Appendix. List of Revisions and Errata

Heat-Straightening Repairs of Damaged Steel Bridges, Report No. FHWA-IF-99-004

Revised Figure 4.27

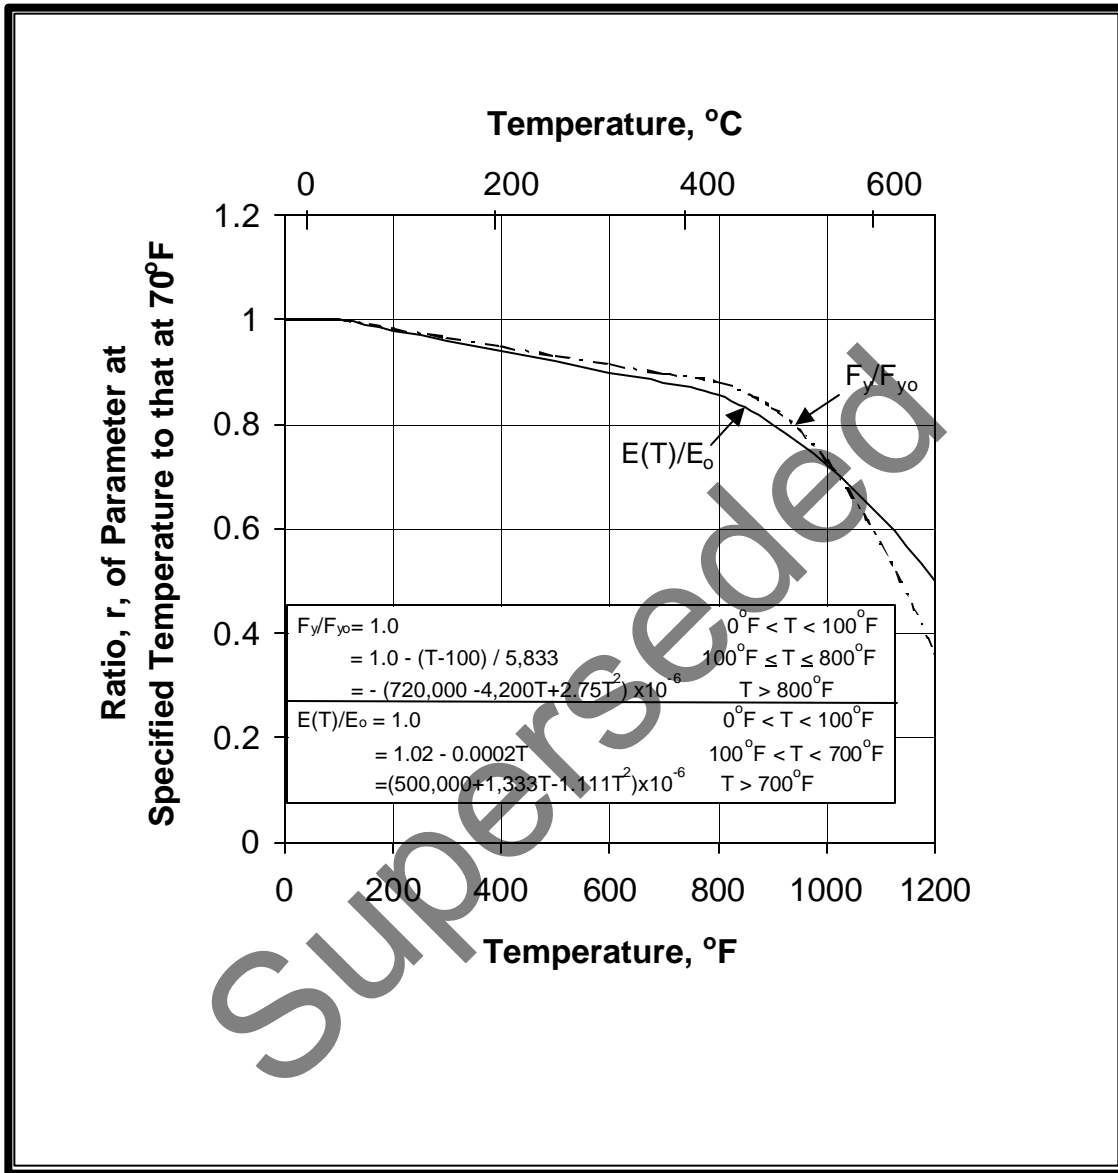
Page	Item	Revision
6	Fig. 1.2 (b), 2nd line of caption	Change “wind” to “ship mast impact”
39	Fig. 3.2 (a)	Dimensions “ L_{r-1} ” and “ L_r ” should read “ L ”
39	Fig. 3.3	Next to last word is figure caption, “cord” should read “chord”
42	Fig. 3.5	“ $R/y_{max} = 8.16$ ” Should read “ $R/y_{max} = 8.15$ ”
44	1st column, 6th line from bottom	“Fig. 3.4” should read “Fig. 3.5”
67	2nd column, line 29	Line should read: “...different formulas are used, depending on ...”
70	2nd column, line 22	“(plate II)” should read “(P-11)”
78	Fig. 4.24 caption	Should read “residual stress distribution For damaged, Category W wide flange beams ...”
80	Fig 4.27	Labels for the two curves should be interchanged and equations for $E(T)/E_o$ should read $E(T)/E_o = 1.0$ $= 1.02 - 0.0002T$ $= (500,000 + 1,333T - 1.1111T^2) \times 10^{-6}$ A corrected figure is attached
90	Table 4.9	Add footnote to table: “* indicates invalid data point”
